**GOVERNMENT OF THE DISTRICT OF COLUMBIA
DEPARTMENT OF TRANSPORTATION**

DATE: October 17, 2014

SUBJECT: Zoning Commission Case No. 14-08 – Portner Place, 1441-1449 U Street NW

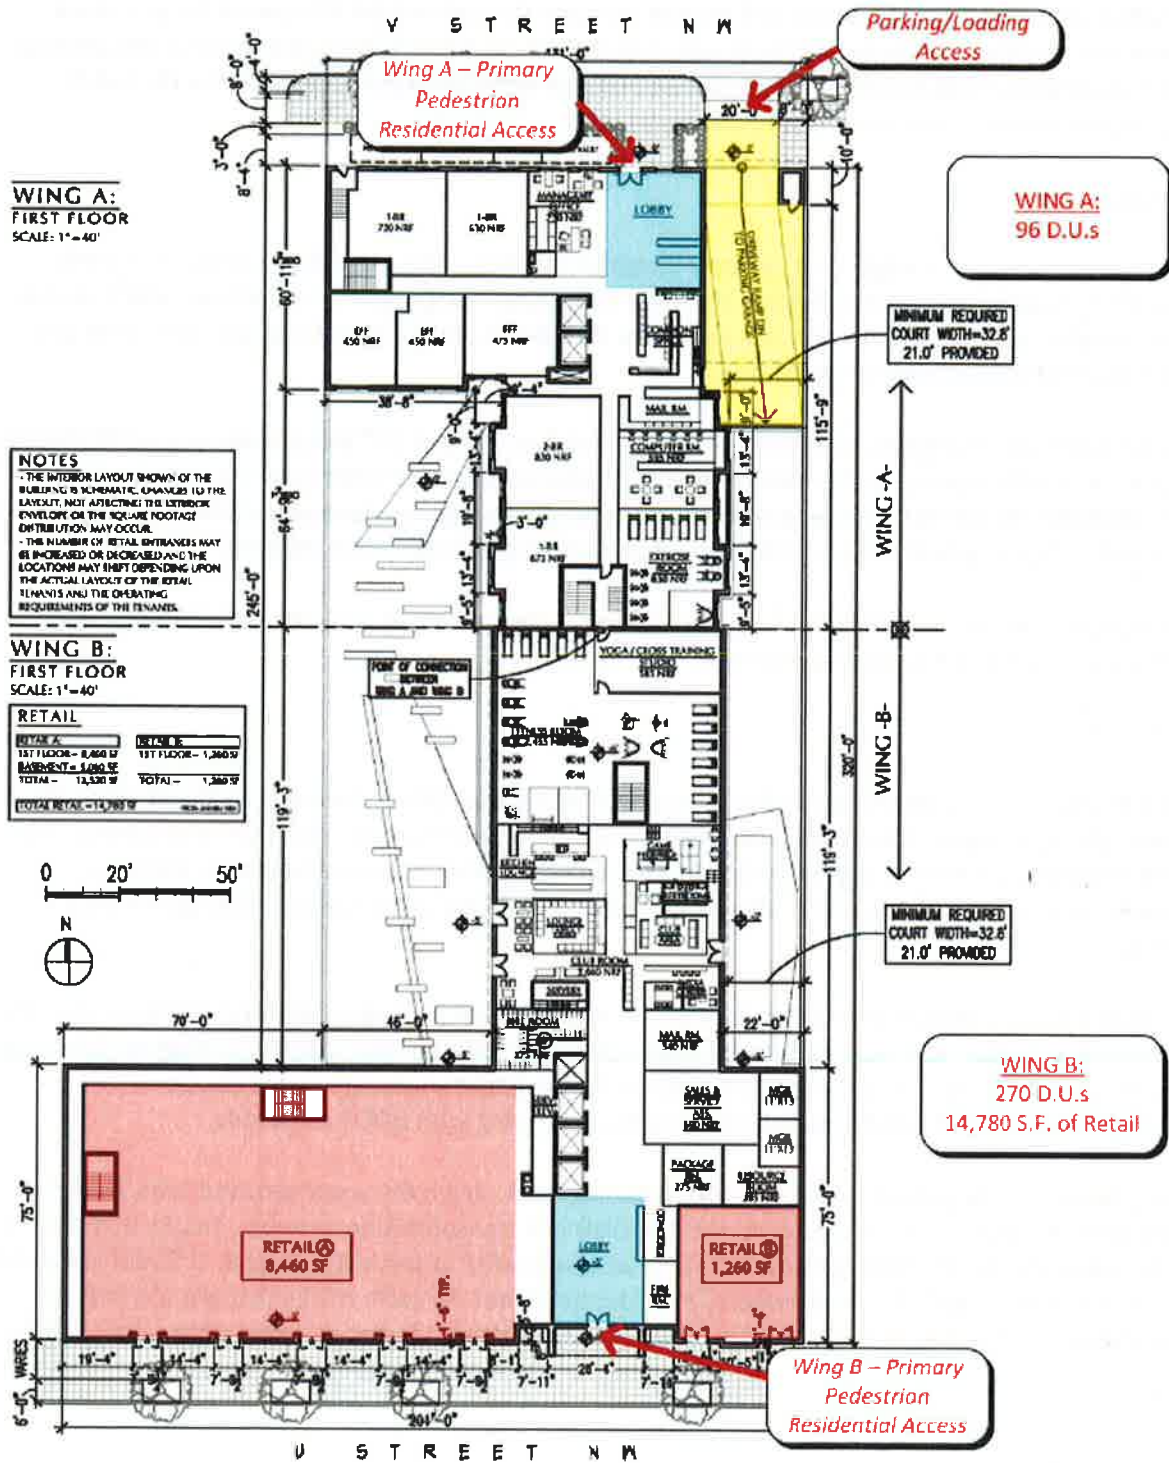
The Applicant proposes a single curb cut on V Street to accommodate vehicular, loading, and trash access. The proposed site access location complies with DDOT's approach to site access, which, in the absence of alley access, requires that site access be provided from the least busy adjacent street and that the number of curb cuts be minimized.

Given the one-way operations of V Street (one-way westbound) and 15th Street (one-way northbound), vehicular site traffic ingressing the parking garage is required to travel westbound on V Street from 14th Street. Likewise, egressing vehicular site traffic from the parking garage is required to travel westbound on V Street until 15th Street before traffic can disperse throughout the road network.
